DOMINION VIRGINIA POWER
NORTH ANNA UNIT 3 COMBINED LICENSE APPLICATION
SRP 09.04.05: RESPONSE TO RAI LETTER 72

RAI No. 5658, Question 09.04.05-5

**SRP SECTION: 09.04.05 – ENGINEERED SAFETY FEATURE VENTILATION
SYSTEM**

9.4.5.2.6 UHS ESW Pump House Ventilation System

Figure 9.4-201 UHS ESW Pump House Ventilation System Flow Diagram

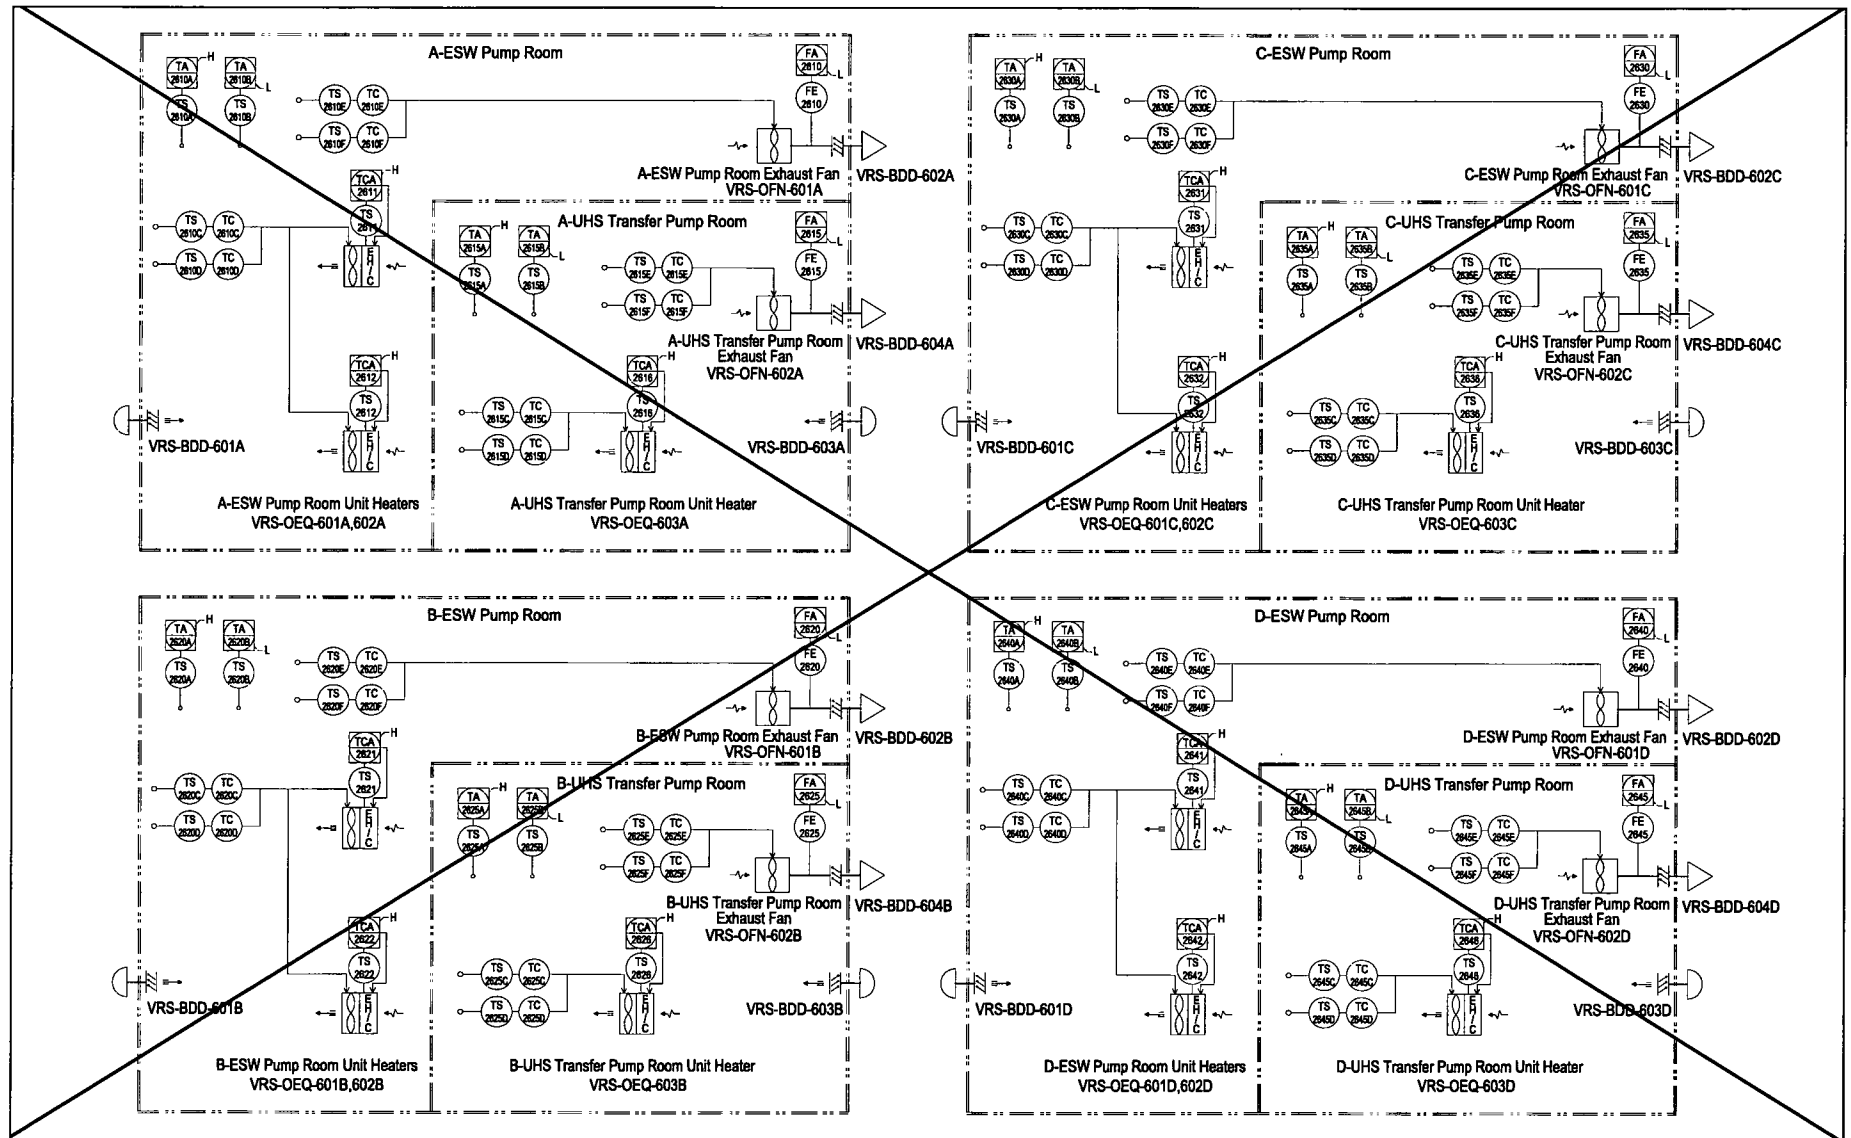
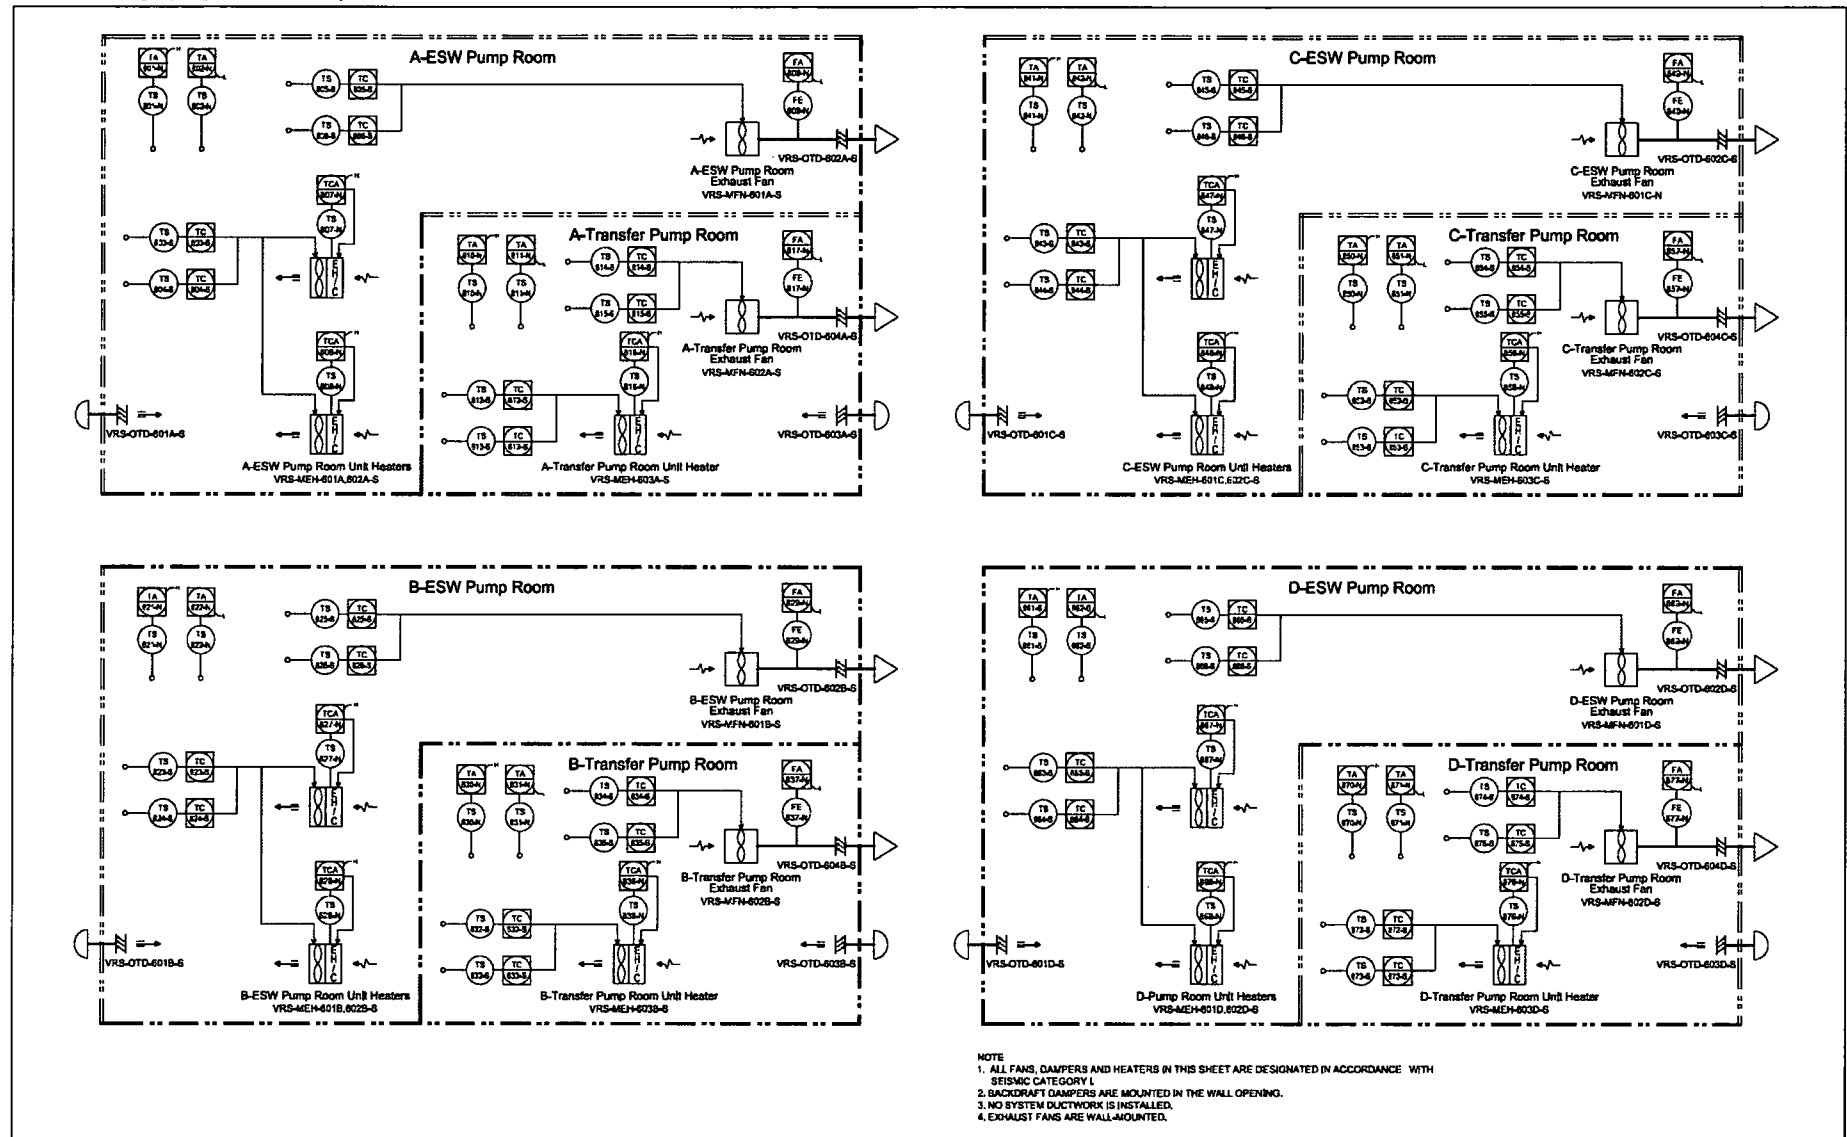
- (2) The temperature switches and associated temperature controllers in the UHS ESW pump houses are safety-related. The temperature controllers are located in series with their respective temperature switches, as shown in FSAR Figure 9.4-201, and are part of a Protection and Safety Monitoring System (PSMS) which starts/stops the associated heaters or exhaust fans. The PSMS used with safety-

The ESW pump and UHS transfer pump room temperature switches will be removed from COLA Part 10, Table A.2-3 and added to COLA Part 10, Table A.2-2, consistent with the Comanche Peak R-COLA. In addition, FSAR Figure 9.4-201 will be revised to indicate that the temperature controllers are part of the PSMS, and a new column will be added to Table A.2-2 to indicate the PSMS control condition.

- Each of the room heaters has an attendant fan displayed in COL FSAR Figure 9.4.201 "UHS ESW Pump House Ventilation System Flow Diagram". However, FSAR Table 9.4-202 does not list a design specification air flow rate for these unit heater fans. Please explain why there is no air flow rate for these unit heater fans.
- What is the impact on the UHS ESW Pump House room temperature when the effect of a 140°F UHS Basin temperature (COL FSAR Table 7.5-201) is combined with the effects of the most severe summertime ambient conditions for the plant site and the heat load from the ESW pump motor?
- What is the expected room temperature in this scenario? Will the ESF equipment within the room remain operable?

FSAR Sections 9.4.5.2.6, 9.4.5.4.6, and 9.4.7, FSAR Tables 3D-201 and 9.4-203, FSAR Figures 9.4-201 and 9.4-203, and COLA Part 10, Tables A.2-2 and A.2-3 will be revised as described in the response and to incorporate revised UHS ESW pump house ventilation system equipment tag numbers. These changes are reflected in the attached markup.
